ERRATA FOR IEEE 1394b THREE-PORT CABLE TRANSCEIVER/ ARBITER TSB81BA3, TSB81BA3I (SLLS559) AND TSB81BA3-EP (SGLS194)

SLLZ015C – DECEMBER 2002 – REVISED MARCH 2006

TSB81BA3 Silicon Errata

This document contains corrections and additions to the following device data sheets: TSB81BA3 (TI Literature Number SLLS559) and TSB81BA3-EP (TI Literature Number SGLS194).

Figure 1. BOSS Arbitration Issue Caused By Mixed Cable Lengths

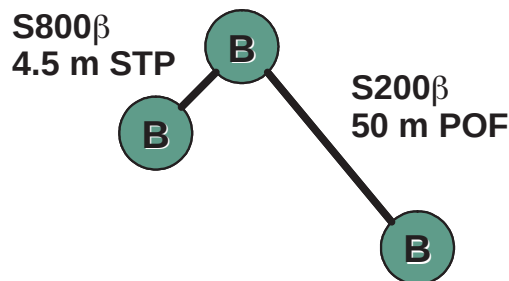
2. BOSS arbitration issue	<u>Symptom</u> A bus-reset may occur in certain topologies when 1394b BOSS arbitration is in use. <u>Occurrences</u> This issue is only possible if three or more BOSS-arbitration capable nodes are connected through a 1394b connection. To be BOSS-arbitration capable a node must have a 1394b PHY and a 1394b Link using the 1394b PHY-Link interface connection. If a narrow timing window is violated (dependent on cable lengths and/or mixed speed bus hops) a middle node may detect a packet collision, causing a PHY state timeout. The state timeout causes a bus reset. Repetitive occurrences result in repetitive bus resets. <u>Example Topologies</u> A. Mixing short and long cable lengths. A BOSS arbitration issue may occur in the middle node. Figure 1 shows an example topology that would exhibit the condition.	A. Use one or more 1394a link-layer controllers (LLCs). If the network only consists of nodes using 1394a link layers, then BOSS arbitration is not utilized; Gap_Count delays are maintained and therefore nodes are not affected by this errata. B. In nodes that do not have a link, disable BOSS arbitration (e.g., force the BMODE pin to the logic 0 state). C. Use a topology where all nodes use the same 1394a compatible bus speed (e.g., S400) and at least one IEEE Std 1394a-2000 node is present. D. Use a topology where all 1394B nodes are at the same 1394b bus speed, using matched cable lengths between 1M and 4.5M.

Figure 2. BOSS Arbitration Issue Caused By Mixed Bus Hop Speeds

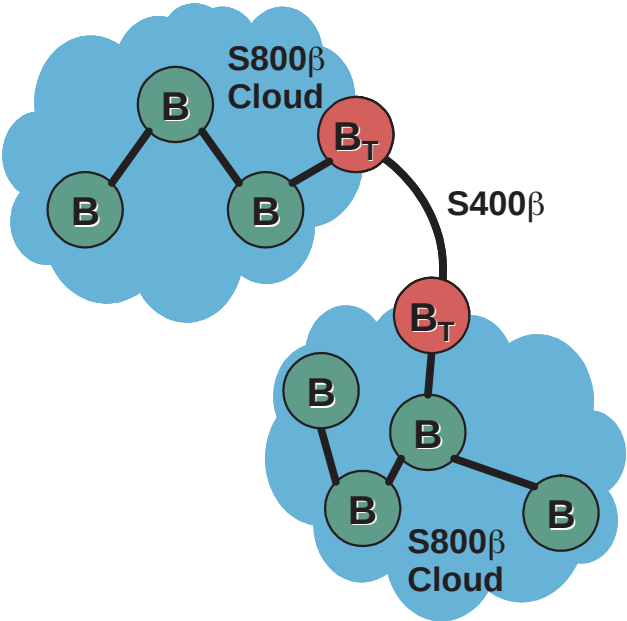
SILICON ERRATA ID	PROBLEM DESCRIPTION	RESOLUTION / WORK-AROUNDS
2. BOSS arbitration issue (continued)	<u>Example Topologies</u> (continued) B. Mixing bus hop speeds. Either transition node (B_T) may have a BOSS arbitration issue. See Figure 2.

Figure 3. BOSS Arbitration Issue—Detailed Example Situation

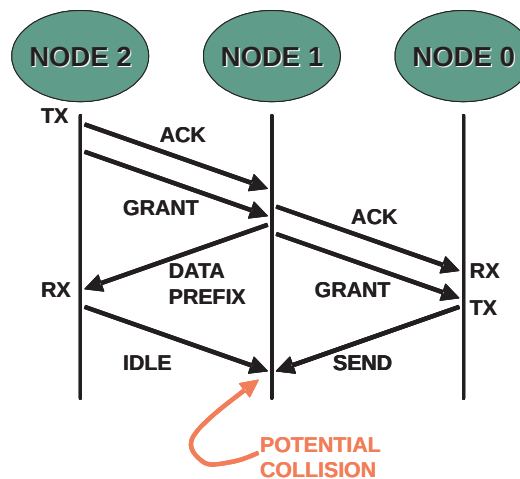
SILICON ERRATA ID	PROBLEM DESCRIPTION	RESOLUTION / WORK-AROUNDS
2. BOSS arbitration issue (continued)	<u>Detailed Example Situation</u> See Figure 3. - Node #2 transmits a high-speed packet that ends an Async subaction or the Isoch period. - Node #2 advances the Async phase (no requests pending for the current phase). - Node #0 has a bus request pending for the new phase. - Node #2 sends an Async grant. - The Async grant is forwarded through a senior node (Node #1) and down through a junior connection to Node #0. - If a narrow timing window is violated the middle node (Node #1) will detect a packet collision, causing a state-timeout while forwarding the grant to the next node. The state-timeout will cause a bus reset.
